6. CASE 22.131, 171 BROADWAY, Charles E. Eddy House, 1858 (BROADWAY)

Applicant/Owner: Jen-Cal Realty Corp., 171 Broadway, Providence, RI 02903
Architect: Mark Rapp, ACME Architects LLC, 9 Simmons Road, Little Compton, RI 02837

Proposal: The scope of work proposed consists of Major Alterations and includes:

Project: Multi-Family Residence
Address: 171 Broadway, Providence, RI 02909
Date: 10 October 2022
Re: Application Information

2
A2.2
PROPOSED CASEMENT
1" = 1'-0"

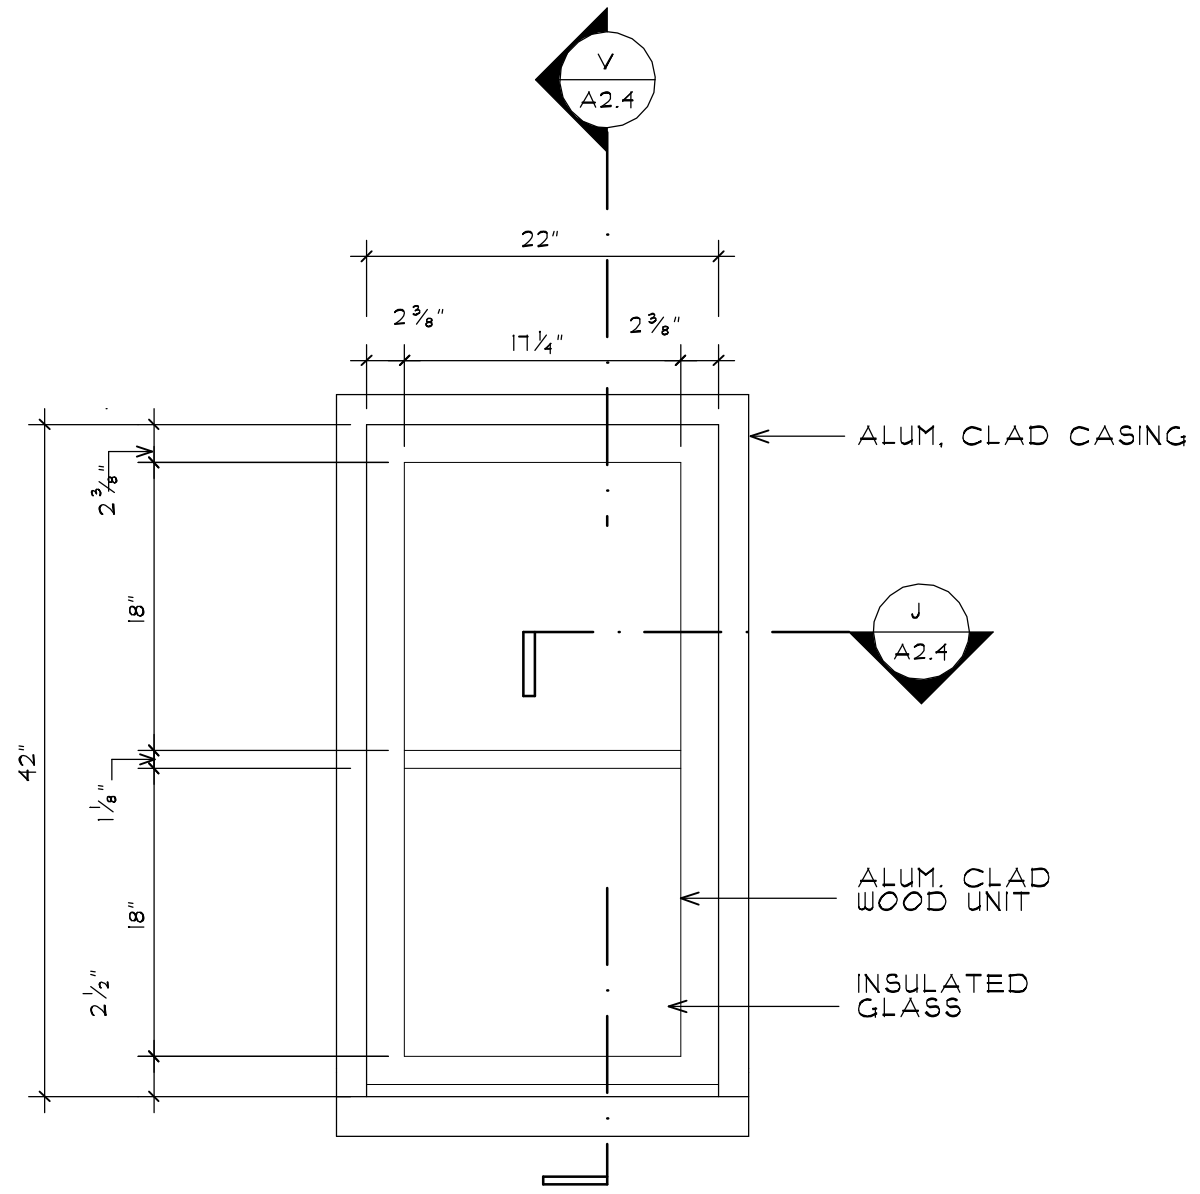
To replace window, within the existing openings, casement function is required to meet current egress requirements. The clear opening must be a minimum of 20" wide, 24" tall and have a clear opening area of 5.7 SF. The proposed units at each end of the gable meet these requirements.

- a) 171 Broadway is a structure of historical and architectural significance that contribute to the significance of the Broadway local historic district, having been recognized as a contributing structure to the Broadway/Armory National Register Historic District;
- b) The application for Major Alterations is considered complete; and,
- c) The work as proposed is in accord with PHDC Standard 8 as follows: as the proposed alterations are appropriate having determined that the proposed construction is architecturally and historically compatible with the property and district having an appropriate size, scale and form that while diminishing the historic quality of the property will not have an adverse effect on the property or district and allows the property to come into compliance with emergency escape and rescue area requirements and RIGL § 42-128.1-8.
